RE: Geotechnical Recommendations & Responses
Oslo Bay Apartments
SR 305
Poulsbo, Washington

In accordance with your authorization, Cobalt Geosciences, LLC has prepared this letter to present responses to City of Poulsbo comments with related geotechnical recommendations.

Section A - Static Stability FS 4.782

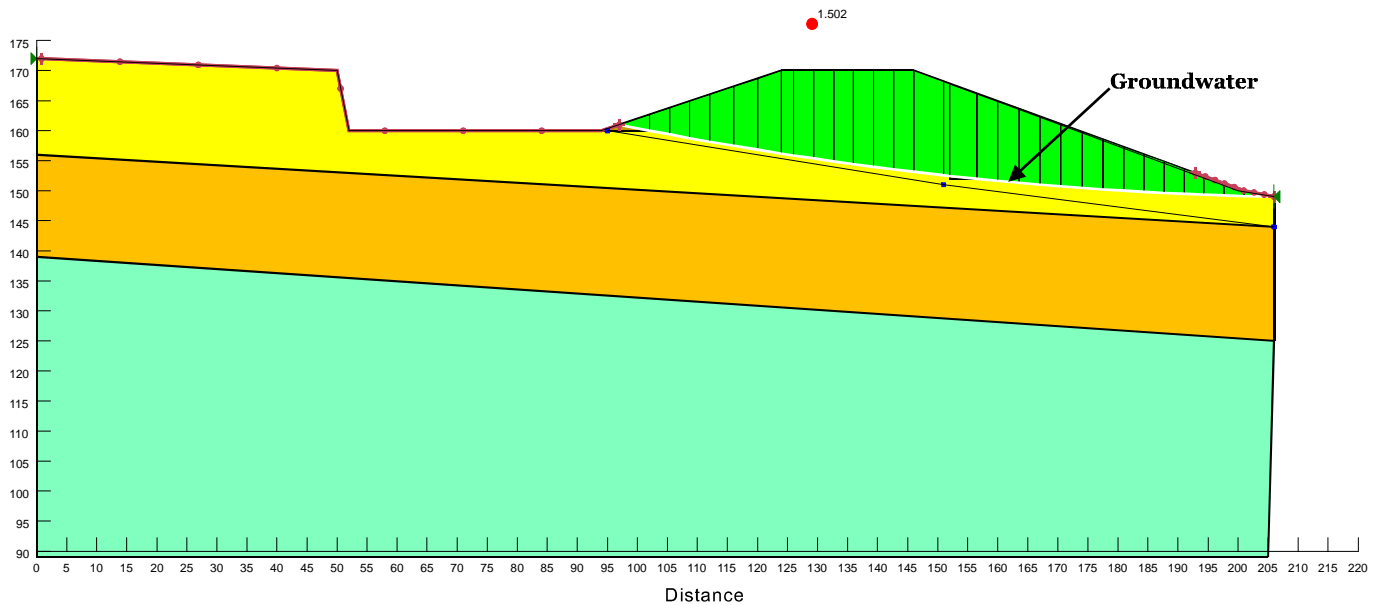
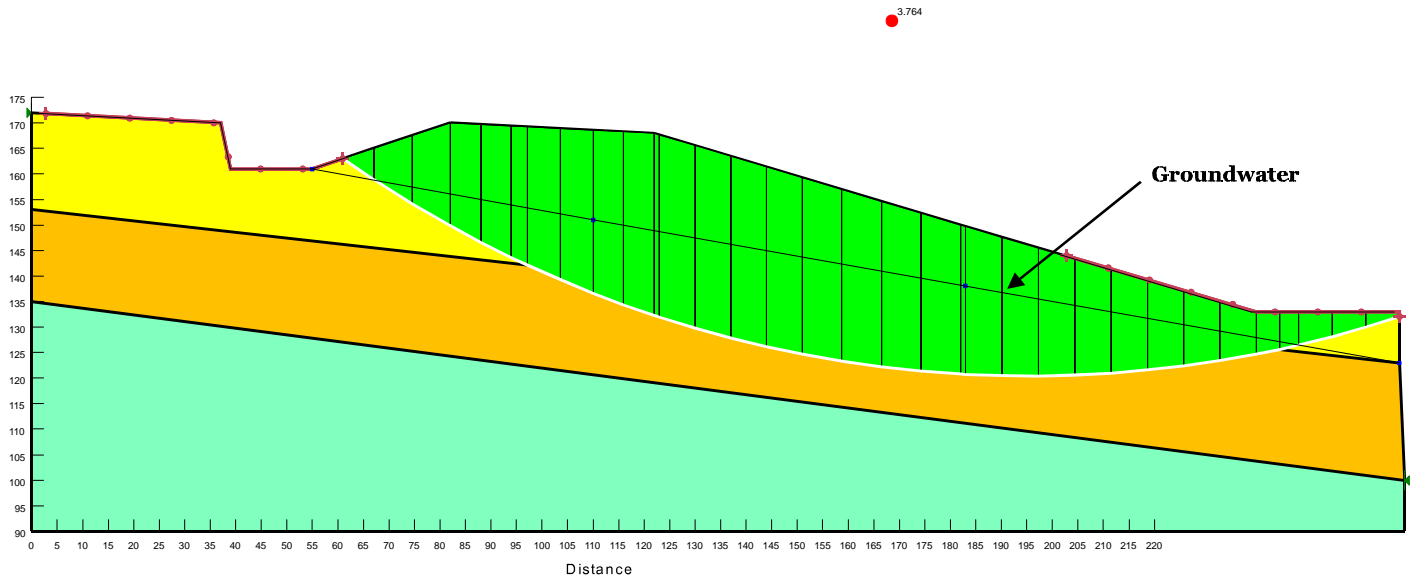
(16) The slope stability sections do not include groundwater. We recommend including a perched groundwater table in the analyses.

We have prepared updated slope stability analyses using an assumed perched groundwater table above the unweathered till. Our analyses used the soil parameters and geometry from the EnviroSound report. Factors of safety are above required minimum values. These analyses are attached.

Section A - Seismic Stability FS 1.502
